SERVICE BULLETIN

APPLICABILITY: 2019MY Ascent NUMBER: 12-254-18

SUBJECT: Loose "A" Pillar Trim DATE: 11/27/18

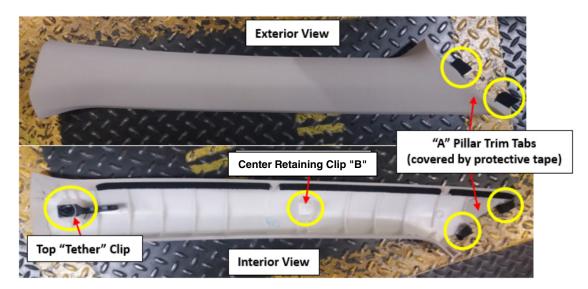
This bulletin provides helpful tips to follow when addressing a customer concern of the "A" pillar trim coming loose.

In addition to the two molded-in tabs which secure the base of the trim at the instrument panel (IP), 2 other clips are used; a tether clip at the top and a second trim clip in the middle. The clip part numbers are: 909150040 ("Tether" Clip) and 909150034 (center retaining clip "B"). Both these clips are one-time use items.

IMPORTANT NOTE: If an inspection of the "A" Pillar trim panel does not find any damage to the clip mounting locations, the trim panel itself may be reused. All clips MUST be replaced as they are one-time use.

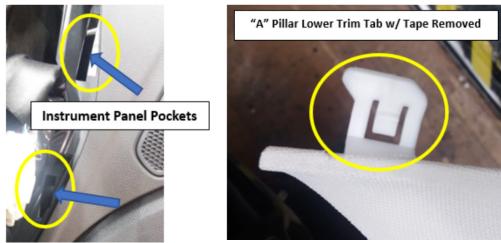
• Whenever a loose "A" Pillar trim is identified, both retaining clips MUST be replaced as they are one-time use. The black "tether" clip goes at the top of the trim panel, closest to the head liner. The trim panel's 2 lower tabs fit into the 2 pockets as shown in the photo on the left.

• This photo shows the 2 holes in the "A" Pillar the trim retaining clips fit into.

CRITICAL: After the 2 new retaining clips are installed onto the trim panel and before installation, confirm all side curtain airbag material is clear of the area around the "A" Pillar center hole where **Clip "B"** fits into.

• Reinstall the "A" Pillar trim; bottom 2 trim tabs first, top Tether Clip second then **Clip "B"** into the "A" Pillar center hole. If necessary, move the trim panel around a bit to be sure both clips are started in their holes before pushing on the trim panel firmly to lock them in place.

• Once the trim panel is clipped into place, **CAREFULLY** insert a trim stick to make a small gap between the trim and "A" Pillar. Use a flashlight as shown below to confirm both retaining clips are fully seated.
